# SERVICETEKNOTES

## TABLE OF CONTENTS

DM44, U3165 A/D I.C. REPLACEMENT

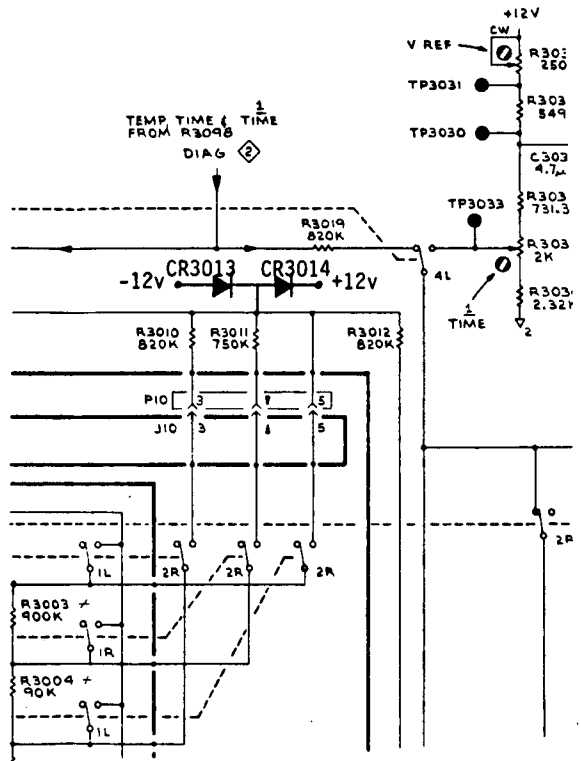
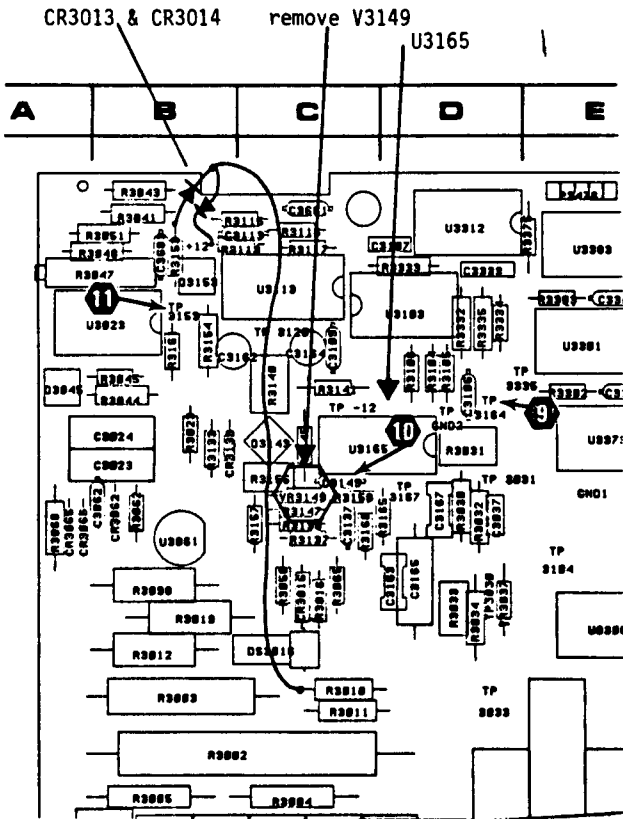
The old I.C., P/N 156-0477-00, used for the A/D processor, U3165, is no longer

available. A new I.C., P/N 156-1268-00, is now used for a replacement. The I.C. is not a direct replacement and the circuit must be modified as follows:

1. Remove VR3149
2. Add CR3013 & CR3014, P/N 152-0323-00, at location shown in the diagram. (CR3013 anode to R3153 [-12 volt supply], CR3014 cathode to R3113 [+12 volt supply], the two diodes are joined together and wired to R3010.)
3. Replace U3165.

GMA102A L.V.P.S. Q5008 MODIFICATION S42417

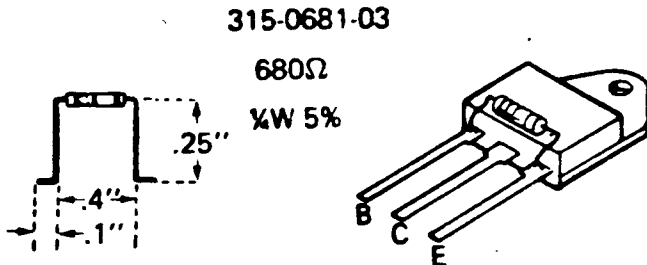
Early GMA102A Low Voltage Power Supplies (prior to serial number B060000) have shown a particular failure mode where R126, R127 and R129 overheat. Other components that typically fail as a result are CR681, Q101, R203, R210, R301, U221 and VR210. This failure occurs when the connector on the leads of Q5008 comes loose.

- Remove R210 (680  $\Omega$ , 315-0681-03) and VR210 (120 v zener) from the 670-5105-04 power supply board. The board level changes to -07 as a result.
- Add another 680  $\Omega$ , 315-0681-03 resistor to Q5008 across the base-emitter junction (see figure). The leads of

R210 will be too short to use; the resistor must not obstruct connecting Q5008's socket.

SPG 2 BURST GAIN PHASE SHIFT

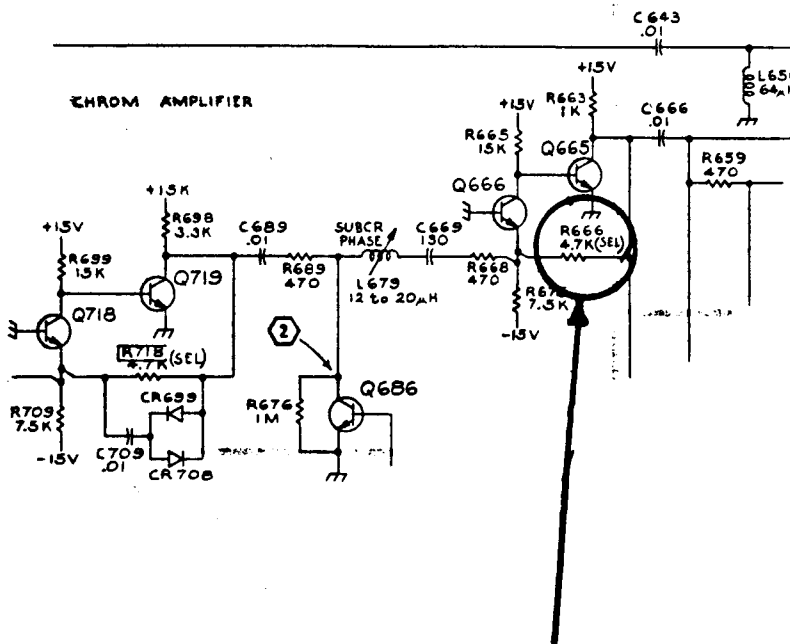
Transistors from different vendors are showing widely varying response characteristics (151-0190-00). This part is used in Q665, Q666, Q718, Q719 and Q715

In the past these transistors have had to be hand selected to keep phase shift with a change in burst gain within specifications.

The addition of a test selectable capacitor (C667, 281-0670-00, nominally 1.8pf) will help avoid this selection routine.

Add C667 in parallel with R666 and select a value between 0 and 4.7pf to obtain minimum phase change with burst gain change, as necessary. See the illustration.

Add C667  
281-0670-00  
(Nominal 1.8pf)

### 528 INTERMITTENT SWEEP & RGB

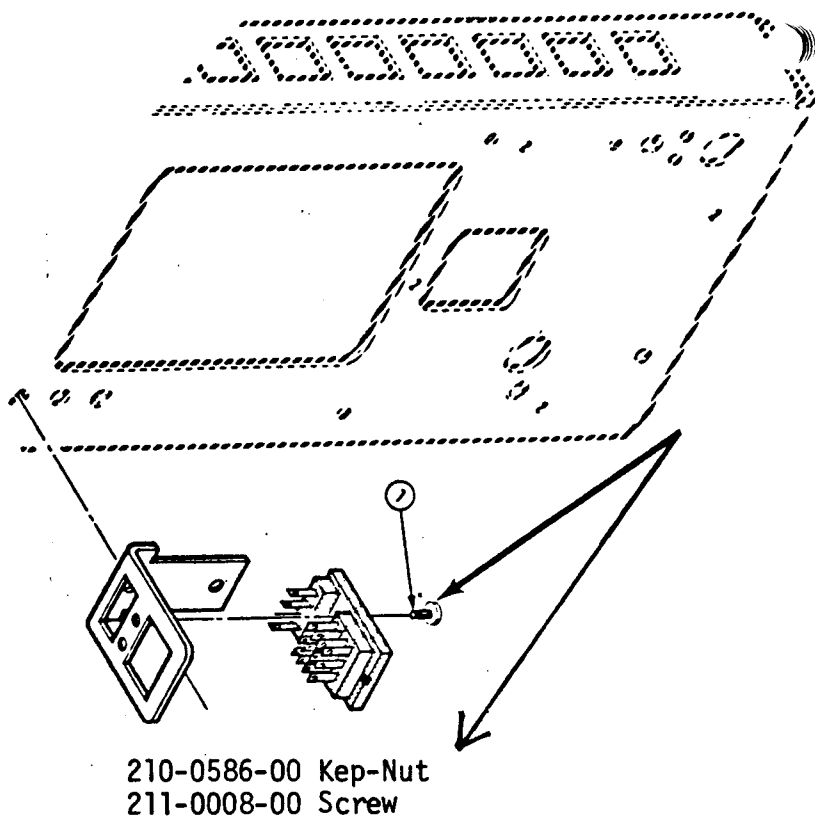
Intermittent sweep and RGB operation has often been caused by poor electrical contact in relay K370.

A new part is available for this application. Use P/N 148-0027-02.

1480 SERIES R6885 CHANGING VALUE

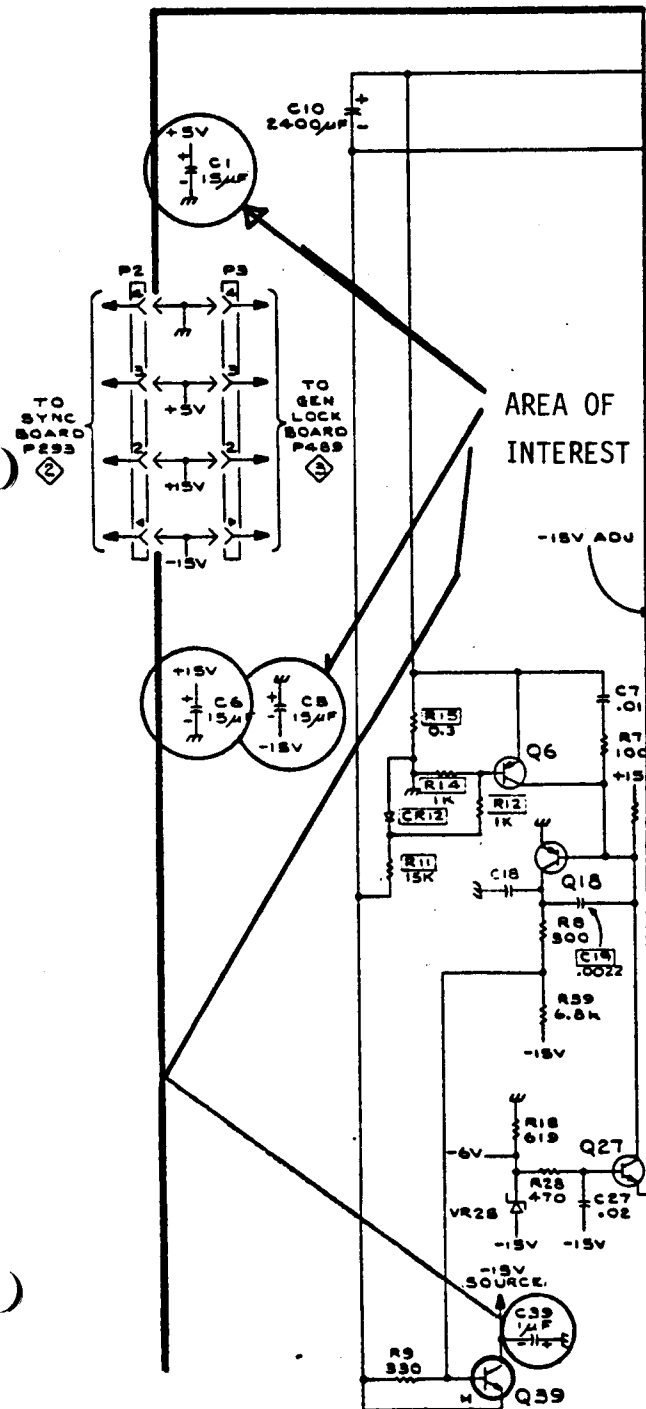
Instances have been found where R6885, a 1K ohm 5% carbon film resistor, changes value when exposed to voltage in excess of 700V for any appreciable length of time. Replace this part with a 301-0102-03 1K 5% carbon composition resistor where failures are discovered.

The resistor is located on the power supply assembly 670-3490-XX.

1800 TEST STATION: FAULT DETECTOR MONITORING UPDATE

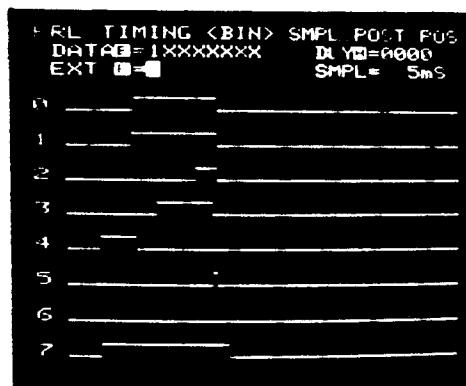
In the Wizard article written September 25, 1981, Issue 11-18, Page 60, there were two oversights. Both oversights were in the second paragraph. U32 is called out as one of the ICs to monitor. This is true for the 670-3782-00. For the later version of the signal sense card 670-3782-01, its IC is U33.

The second oversight is with data that is used by the DATA Trigger. The data should be entered as 1,X,X,X,X,X,X,X. The difference being the 1.

A clarification of the display follows. Figure 1 is a photo of the 308 after a fault was forced by shorting -15 volts to ground. In this case #4 (-15 Volt monitor) the leading edge is coincident with the leading edge of #7 (Power Status). The other pulses are a result of -15 volts being shorted.

1900 KEYSWITCH BOARD FAULT

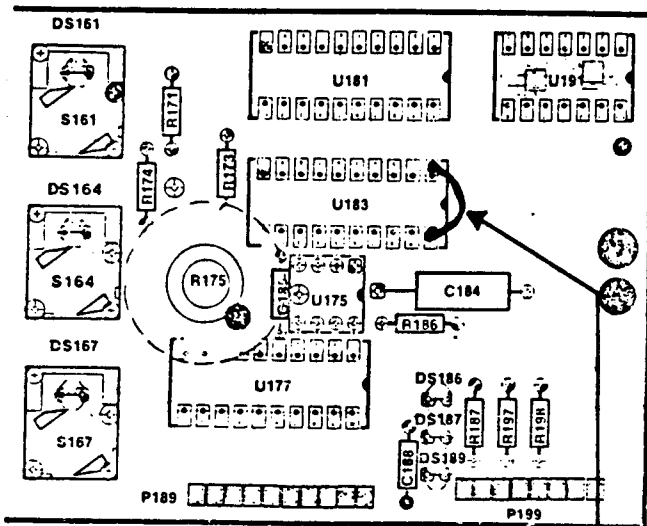
A floating "clear" pin on the A13 Key-switch board can allow more than one LED to be on at one time. The LED's affected are DS121, DS124, DS127, DS131, DS134, DS137. This problem shows up more often when using the diagnostic PROM (067-0964-00) to test the instrument. To correct this fault, add a wire strap from PIN 1 to PIN 20 of A13U183. (See diagram below.)

NOTE: The manual schematic is in error. U183 is labeled as U188.

Install this wire strap whenever a 1900 is in for service.

Add wire strap to the back of the board from Pin 1 to Pin 20, U183.

4631: HARD COPY NOISE AND RAMP OSCILLATION MOD TO TIMING BOARDSymptoms

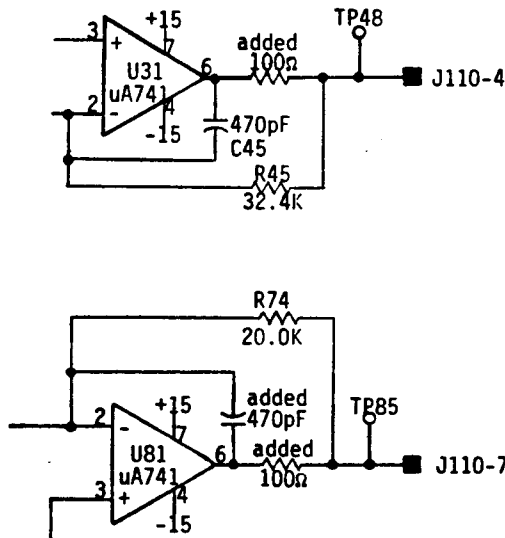
Hard copy image is noisy at the top, or weak at the bottom of the page. The "interrogate" scan line may be broken up (or a series of dots) at one end. The slow ramp may start one inch to the right of where it should start.

Load capacitance can cause the uA741 Op Amps--Slow and Fast Ramp Drivers--to oscillate. Usually this is due to long (ARTICLE CONTINUED ON THE NEXT PAGE)

Add 100 ohm resistors in series with the ramp outputs. Add a 470 pF capacitor from pin 6 (output) to pin 2 (inverting input) of U81. Note schematic corrections below.

1. Orient the board with edge connector toward you, component side up.
2. Lift pin 6 of U31. Lift the right end of C45 (on top of R45) and solder it to the lifted pin 6. Solder a 100 ohm, 1/4 w, 5% resistor, p.n. 315-0101-00, from the right end of R45 to the lifted pin 6, U31.
3. Lift pin 6 of U81. Solder a 470 pF capacitor, p.n. 281-0580-00 across

the top of U81 from pin 2 to the lifted pin 6. Solder a 100 ohm, 1/4w, 5% resistor, p.n. 315-0101-00, from lifted pin 6 to TP85.

4. Change the part number suffix of the board to 670-3661-09 or 670-5740-02.

Figure 2-6. Attached Parts Location.

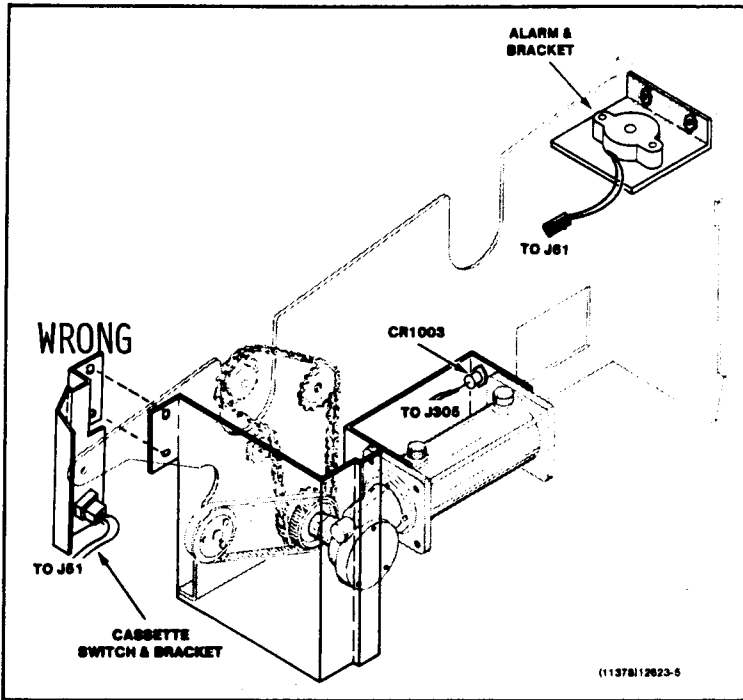
An error in the installation instructions for the (jam) Detector Board Kit, CM020-0814-00, may confuse both Tektronix and OEM customer service personnel. On page 2-9, Figure 2-6 shows the cassette switch bracket mounted to the left of a flange from the front subpanel. The correct mounting location is on the right side of the flange. The figures below should clarify.
